APPLICATION NO.	FILING DATE	FIRST NAMED INVENTOR	ATTORNEY DOCKET NO.	CONFIRMATION NO.
10/500,583	06/29/2004	Jan Webjorn	P/4447-3 PCT	5248
2352 OSTROLENK	7590 08/13/2007 FABER GERB & SOFFEN		EXAN	1INER
1180 AVENU	E OF THE AMERICAS		NAHID	
NEW YORK,	NY 100368403		ART UNIT	PAPER NUMBER
			3679	
		•		
			MAIL DATE	DELIVERY MODE
			08/13/2007	PAPER

Application No.	Applicant(s)				
Office Action Summary	10/500,583	WEBJORN, JAN				
Office Action Summary	Examiner	Art Unit				
	Nahid Amiri	3679				
The MAILING DATE of this communication ap Period for Reply	pears on the cover sheet with the c	correspondence address				
A SHORTENED STATUTORY PERIOD FOR REPLY IS SET TO EXPIRE <u>03</u> MONTH(S) OR THIRTY (30) DAYS, WHICHEVER IS LONGER, FROM THE MAILING DATE OF THIS COMMUNICATION. - Extensions of time may be available under the provisions of 37 CFR 1.136(a). In no event, however, may a reply be timely filed after SIX (6) MONTHS from the mailing date of this communication. - If NO period for reply is specified above, the maximum statutory period will apply and will expire SIX (6) MONTHS from the mailing date of this communication. - Failure to reply within the set or extended period for reply w

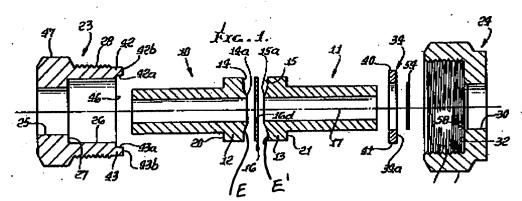
With respect to claim 1, McManigal discloses a flanged member (Fig. 1) to be included as a first flanged member (12) in a flanged joint; wherein the flanged member (12) comprising a first flanged end with a first end surface (E) configured to be assembled together with a corresponding end surface of a flanged end (E') of a second flanged member (13) in the flanged joint, at least a portion of the first end surface (E) in unstressed condition being concave in a radial direction such that the at least a portion of the first end surface (E) is curved and defined by a concave curve function; and wherein in an unstressed condition a proximal point on the at least the portion of the first end surface and a distal point of the at least the portion of the first end surface meet a plane inclined in the radial direction of the flanged member (12).

With respect to claim 2, McManigal discloses (Fig. 1) that the first end surface is concave over the entire extension thereof in the radial direction.

With respect to claim 3, McManigal discloses (Fig. 1) that the first end surface (E) is concave in the radial direction over at least an area that will be subjected to deforming forces when the flanged member (12) is assembled together with another flanged member (13).

With respect to claim 4, McManigal discloses (Fig. 1) that the first end surface (E) is concave over essentially a contact surface against the corresponding end surface (E') of the second flanged member (13).

With respect to claims 5 and 14, McManigal discloses (Fig. 1) that the first end surface (E) comprises varyingly concave surface in the radial direction; and wherein the concave surface (E) has more than one radii of curvature.

With respect to claim 10, McManigal discloses (Fig. 1) that at least a part of a transition area, between the surface of the flange directed away from the end surface and a part of the flanged member that is substantially parallel to a longitudinal axis of the member, is shaped as a substantially elliptical area.

With respect to claim 11, McManigal discloses a Joint (Fig. 1) comprising two flanged members (12, 13); the two flanged members (12, 13) each comprising at least one flanged end having an end surface (E) connecting together the two flanged members (12, 13) in an assembled state such that the end surfaces face each other, wherein at least one portion of the end surface in an unstressed condition is concave in a radial direction such that the at least the portion of the

With respect to claim 12, McManigal discloses (Fig. 1) both of the flanged members (12, 13) have a concave end surface.

With respect to claim 13, McManigal discloses (Fig. 1) the end surfaces (30, 16) facing each other before assembly are inclined in the radial direction outwards to form an angle in radial cross-section, the angle being such that a distance between the two end surfaces (E, E') increase in radial direction outwards, and at least one of the inclined end surface being slightly concave; and wherein the concave surface has more than one radii of curvature.
